**TAMPA-HILLSBOROUGH COUNTY
EXPRESSWAY AUTHORITY**

Addendum No. 3

Renovation Services ~ THEA TMC

RFP O-01120

Roof work (if required) – to be scheduled during ideal weather conditions

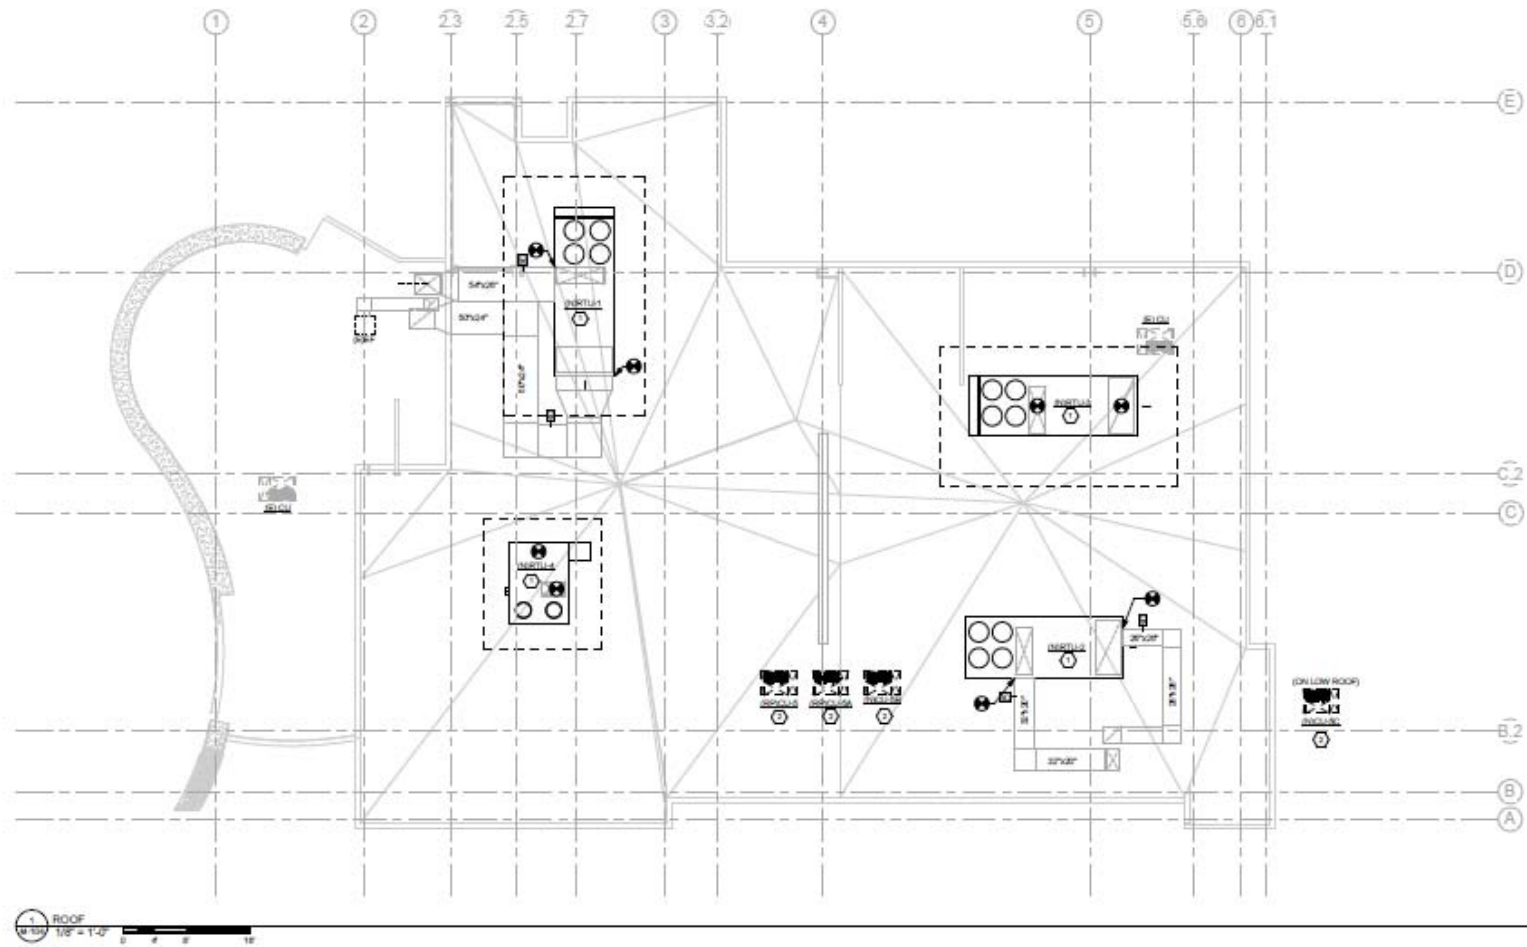
Alternate No. 4: Revised phasing plan to include staged access to the 2nd and 3rd floor renovation areas sequentially.

Response 70:	That is correct. Base bid assumes that the contractor would have access to perform work on all floors simultaneously. Schedule, means and methods are up to the contractor with some limitations regarding the TMC, server rooms and the like, which must remain in operation. The alternate 4 would require phasing of the renovation one floor at a time, likely beginning with the 2nd floor, then 3rd floor with 1st floor last. The first floor would be used as temporary "swing space" to accommodate THEA personnel during phased renovations. See Phasing Plan included with this Addendum

SK-3.0

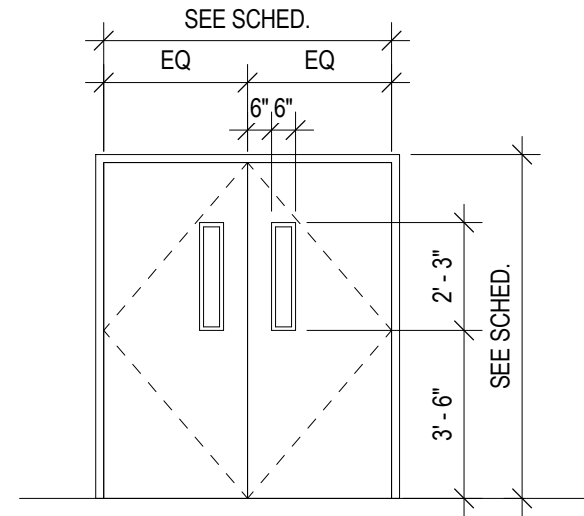
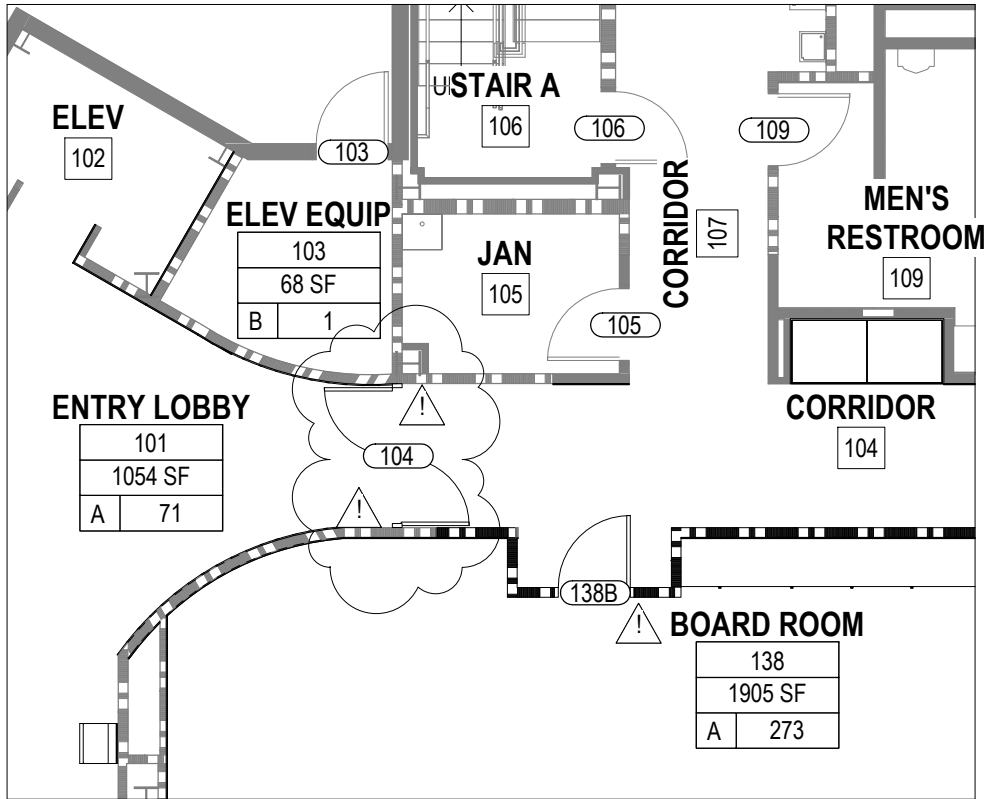
- Responses to Bid Questions submitted on or before August 21, 2020
- Revised Bid Form (revised 8/31/20)
- Anticipated SBE Participation Statement
- THEA TMC Proposed Phasing Plan – Bid Alternate #4, revised 8/28/20
- List of Pre-Bid Meeting Attendees
- Sketch 3.0 – design revision to Door 104 (related to city permit review)

45 MIN/ NEW CARD READER/ DOUBLE EGRESS WITH PANIC HARDWARE

Hardware Group No. 04 - CARD READER, MAGLOCK

CARD ACCESS SYSTEM BY SECURITY SUPPLIER TO RELEASE MAG LOCK FOR ACCESS. CARD READER TO BE SUPPLIED BY DIV. 28. FREE EGRESS FROM THE CORRIDOR SIDE.
